APPEAL SUMMARY

| Building/Business Name: Alta ART Tower | Fire Sprinklers: Yes - Through out |

Description: Code Equivalency - Use of Alpolic® /fr Panels for Exterior Wall Covering (Soffit)

EXTERIOR SOFFIT - LEVEL 2 AND LEVEL 21

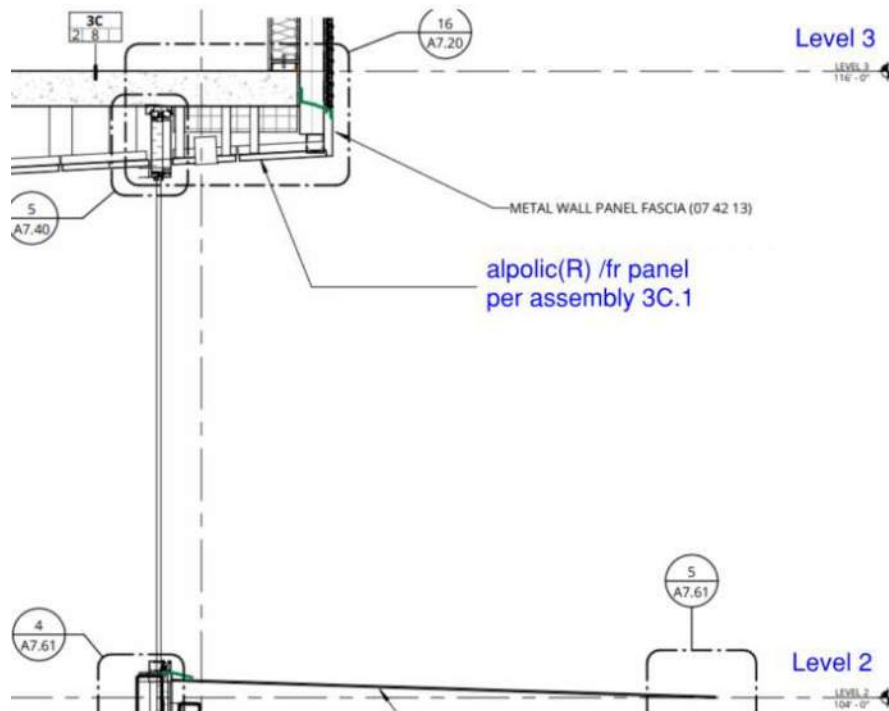
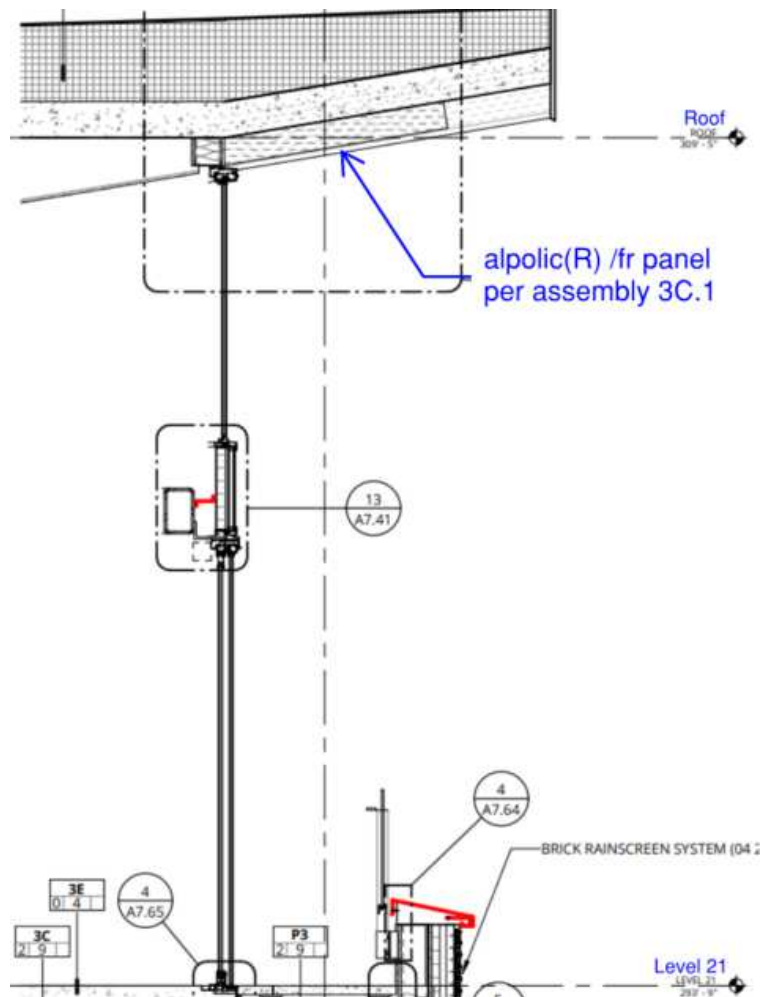
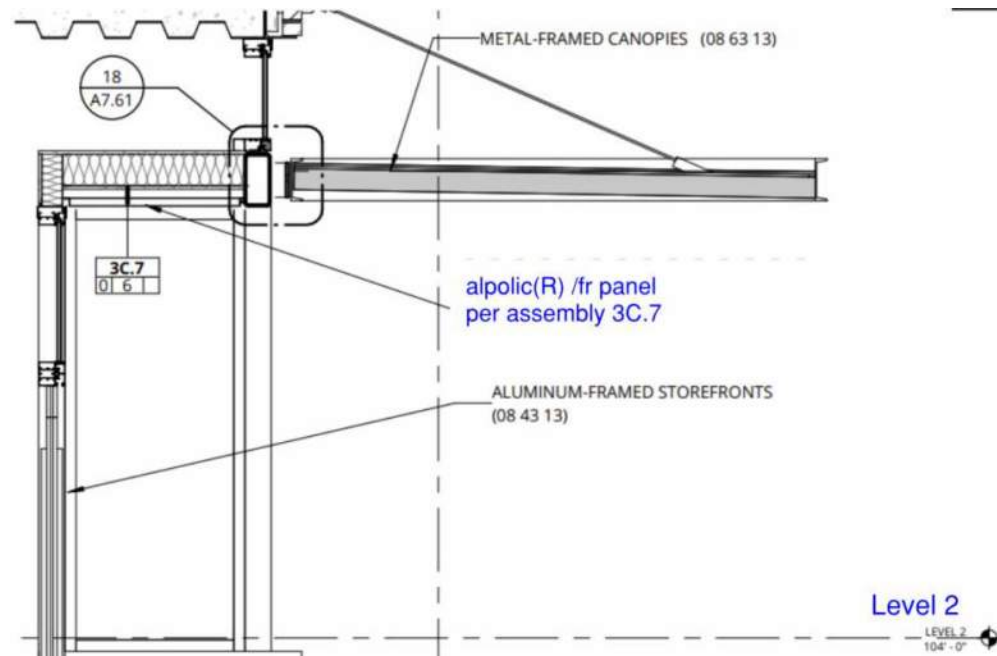
Proposed Designs: It is proposed to use Alpolic® /fr panels on exterior wall coverings as part of the soffit assemblies identified as 3C.1 and 3C.7, as follows:

For assembly 3C.1, the 8-inch concrete slab will provide a 4-hour fire-resistance rating based on Table 722.2.2.1. By comparison, this rating exceeds that of the required thermal barrier (15-minute) and the tested assembly (1-hour).

Similarly, for assembly 3C.7, the increased thickness of the mineral fiber insulation and steel studs will not reduce the fire performance level of the tested assembly. Based on Harmathy's Rule #2 for fire endurance ratings, "the fire endurance of a construction does not decrease with the addition of further layers." In this case the increase thickness can be considered further layers which would not decrease the performance level of the wall assembly.

Section 1407.10.2 also requires that MCM be separated from the interior of a building by a thermal barrier consisting of at least 1/2-inch of gypsum wallboard, which provides 15 minutes of protection based on Table 722.2.1.4(2). This has been achieved in the proposed designs via the 8-inch concrete slab or 5/8-inch thick Type X gypsum boards. In addition, the Alpolic® /fr panel will also be separated to the interior space on ends where the panel meets the exterior wall by a wall assembly compliant with Section 4.3 of ESR-2653 or thicker layers providing at least the same thermal barrier requirement.

Use of metal composite panels in lieu of metal panel at exterior soffits: Granted as proposed.
